RE: Consent # BCO10364430
362 Matakana Valley Road.

REPLACEMENT PLANING SHED

362 MATAKANA VALLEY ROAD
MATAKANA

Application Number	BCO10364430	Date of Request	05 Apr 2023
Site Address	362 Matakana Valley Road Matakana 0985		
Brief Description of Application	DBC - Replacement market sheds and 10 workshops including toilet facilities		
Link to Application	U:\COO\Building Control\Northern Building Control\BC Consents - OREWA\Live BCs Processing\BCO10364430 - 362 Matakana Valley Road		
Other Project Reference (if applicable)			
Regulatory Engineer	Nicole Li	Engineer Contact #	
Application Type (please select)	BCO		
If Resource Consent, please provide processing planner name and contact:			
Name:			
Email Address:

SECTION BB

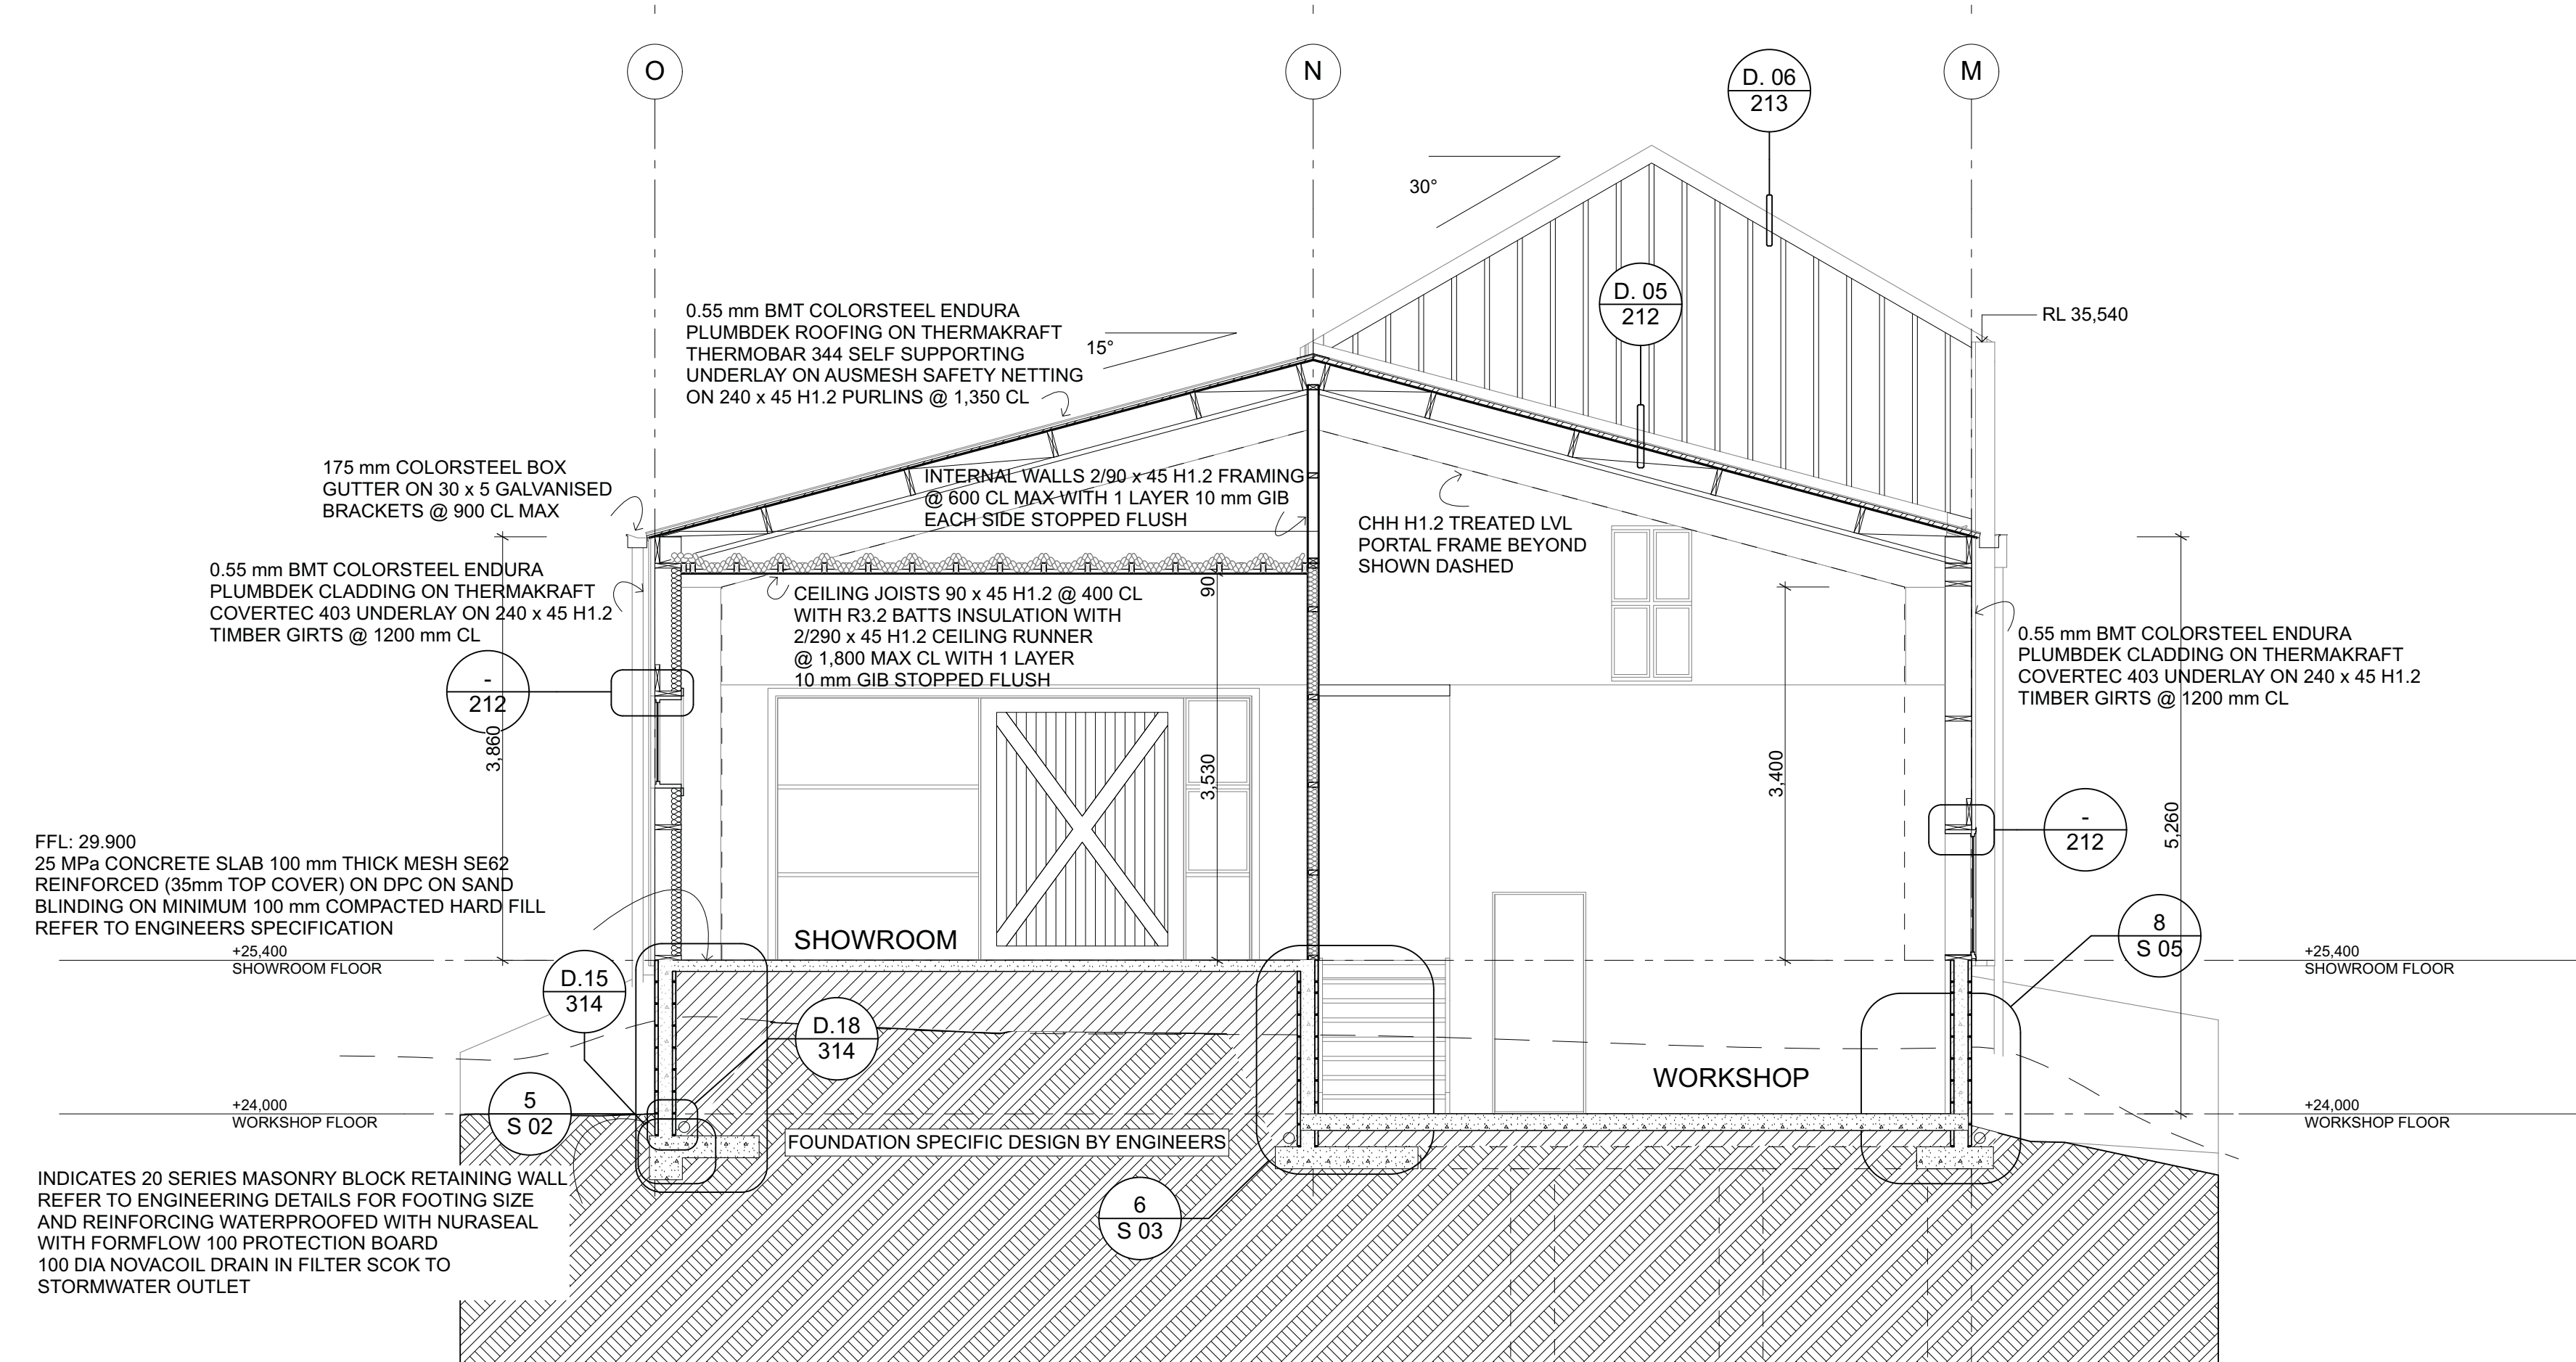
41. Please provide wall cladding clearances detail for Macrocarpa rainscreen with Hardi-flex cladding in accordance with figure 65 and table 18 of NZBC E2/AS1.

39. Notes copied on to sheet 121E.
40. Risk Matrix added to sheets 103,104,115E.
41. The macrocarpa rain screen is decorative. The cladding is hardiflex which laps over the concrete masonry wall base 1,000mm high refer to section BB. This is over 150mm clear of the finished ground level.

05/05/2023 Accepted – the agent confirmed that, the macrocarpa rain screen is decorative purpose only. And the masonry wall base is 1M high, so wall cladding clearance meet the requirement – section BB on sheet 106 checked ok. Also wall cladding clearance detail for hardiflex sheet provided on sheet 28.1.

D. 08 SLIDING DOOR HEAD 1:5

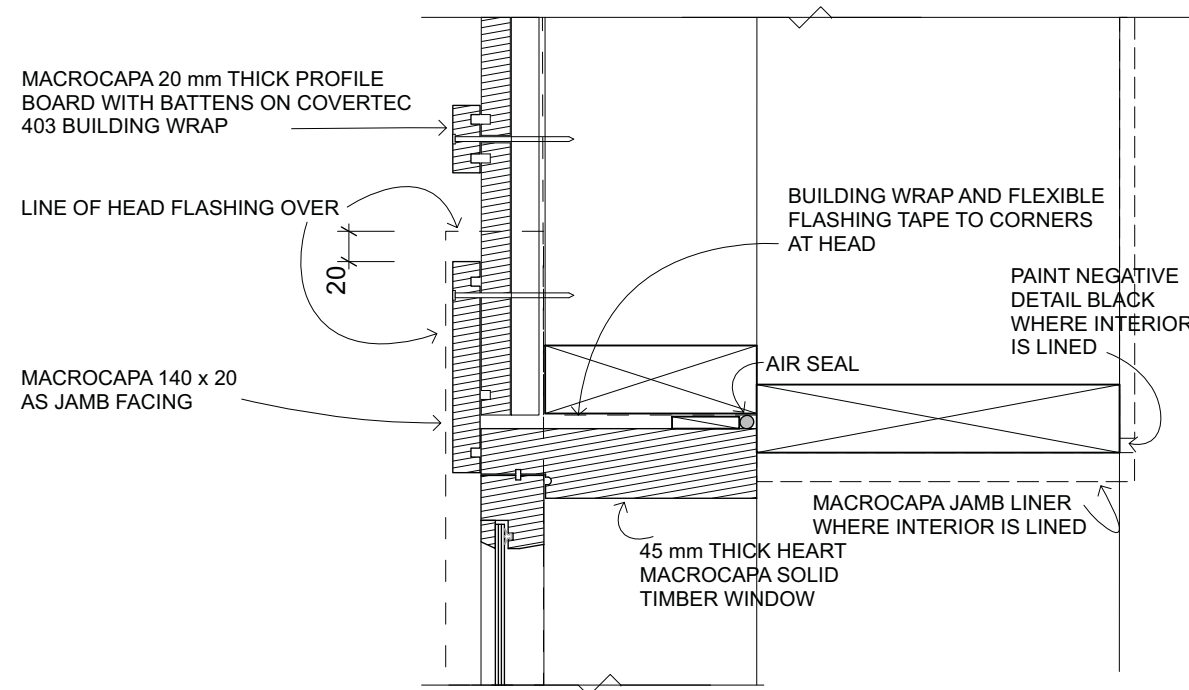
26. Please revise the max threshold levels specified on detail D-08 on sheet 127. This should be 20mm as noted on floor plans and in accordance with paragraph 1.3.2 of D1/AS1.

05/05/2023 Accepted – the note (detail D-08 on sheet 127) revised as 20mm

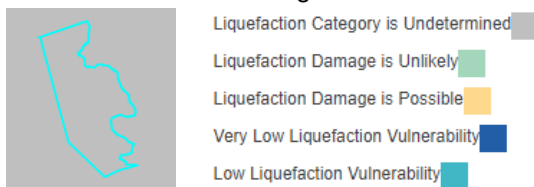
7. Please indicate finished ground levels on site plan (sheet 101) – the spots of FGL should be around the proposed buildings, carparks, driveways, effluent field area ...ect. You may provide an enlarged part site plan for clear siting datum information.

05/05/2023 Accepted – FGL indicated on additional enlarged site plan (sheet 01.1)

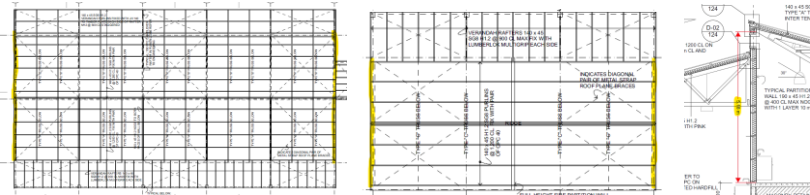
9. Please confirm any specific engineer's design is required for the pipe penetration to the footings.

05/05/2023 Accepted – additional service penetration requirement note added on revised plans

(sheet 107, 112, 117 and 122) as confirmed by engineer.

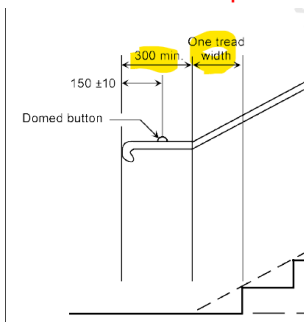
30. Please provide accessible handrail detail/requirement (e.g. extensions ...etc) on plan in accordance with fig.25 of D1/AS1.

09/05/2023 Not Accepted – the extension requires 300mm plus one tread width

09/06/2023 Accepted – detail provided on revised sheet 133

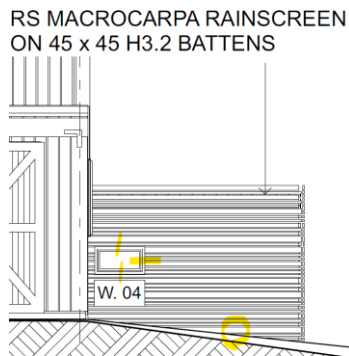
39. Please provide note for the roof plan of shed 2 and specify the size and type of gutter, roof type and falls...etc. No note provided on sheet 121.

05/05/2023 Accepted – notes for roofing added on revised sheet 121

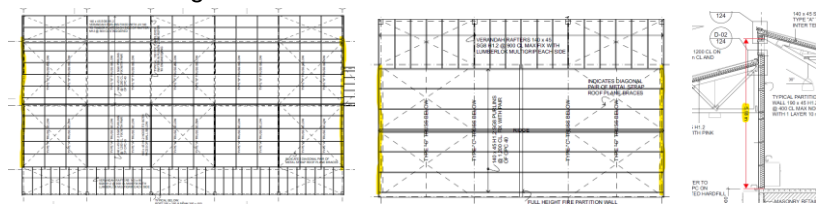
10. Please provide gable end wall framing requirement on plan to show compliance to NZBC B1. Please note that, no gable end trusses have been provided as per the roof framing plans (shed 1 – sheet 109 and shed 2 – sheet 119) provided.

If full height stud to be used, the max. wall stud height will be greater than 5M (for shed 1) and this is outside scope of NZS3604:2011. So please provide engineer design (including PS1 and supporting calculation) by qualified engineer who is registered in Auckland Council Producer Statement Author list with covering NZBC B1.

05/05/2023 Accepted – external wall framing calculation provided by engineer, the note added on revised sheet 102 and 114 added

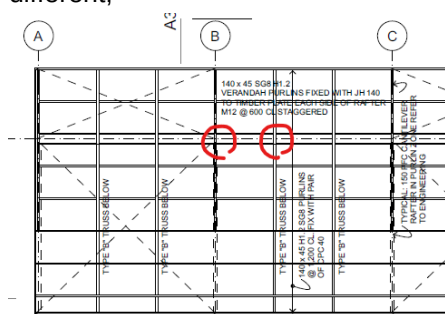
13. Please provide types, sizes and fixings of the lintels for the doors and windows openings on plans to show compliance to NZBC B1.
14. Please provide manufacturer's installation instruction for selected wall bracing elements (i.e. GS1-N and GS2-N) on sheet A401.
15. Please provide/clarify the cantilevered roof framing members and connection to trusses or rafters on plan to show compliance to NZBC B1.

05/05/2023 Accepted – lintel size and fixing type provided on revised sheet 108 and 118 in accordance with table 8.9 of NZS3604:2011 or as per engineer's requirement (engineering calculations provided) and lintel fixing installation added on sheet 135 as per Studlok

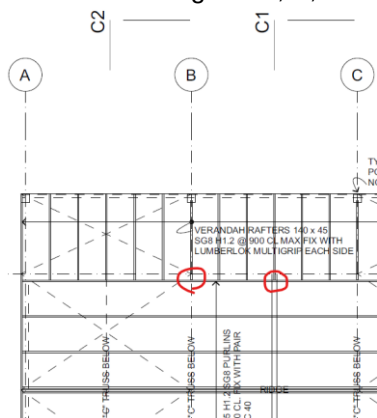
- For shed 1 - provide project-specific connection/fixing details as the roof framing connections on grid A, B, C, D, E and F, and the connections between grids could be different,

05/05/2023 Accepted – detail D5 on sheet S205 checked ok. And agent confirmed that the 150 PFC to be placed on top of trusses @2M to all the cantilevered roof – this has been indicated/revised on sheet 109

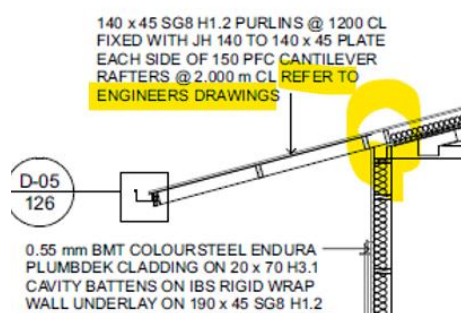
- For shed 2 - provide project-specific connection/fixing details as the roof framing connections on grid C2, B, C and D, and A and C1 could be different

05/05/2023 Accepted – type C truss fixings as per engineer's requirement, detail A-A on sheet S205 checked ok. And the verandah rafter to post fixing refer detail D-03 on sheet 125

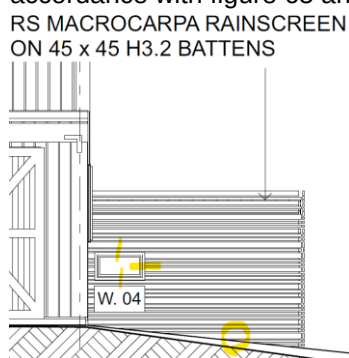
34. Please clarify how compliance is achieved with the NZBC clause G5.3.4 for the proposed new counter/ reception. If the workshops will be used as retail purpose, new counter/ reception desk need to be placed in every workshops. So provide the details of the accessible reception desk on plan.

G5.3.4 Where reception counters or desks are provided for public use, at least one counter or desk shall be accessible.

34. No reception counters are proposed or required. G5.3.4 only applies if these are provided.
35. Please refer to sheet 101.1E.
36. Refer to above.
37. Stormwater dispersal has been revised to a concrete bound rock spall as per the Engineers advice. This detail has been added to sheet 122E. Location is marked on sheet 101.1E

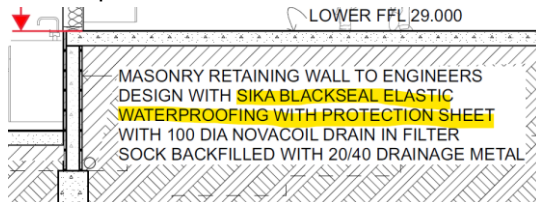
42. Please provide window head, jamb and sill details for trapezoidal profiled metal cladding on plan to show compliance to NZBC E2.
43. Please provide roller door head, jamb and sill details on plan to show compliance to NZBC E2.
44. Please provide window head, jamb and sill details for Macrocarpa rainscreen with Hardi-flex cladding on plan to show compliance to NZBC E2.

05/05/2023 Accepted – window head, jamb and sill details for trapezoidal profiled metal cladding added on additional sheet 128
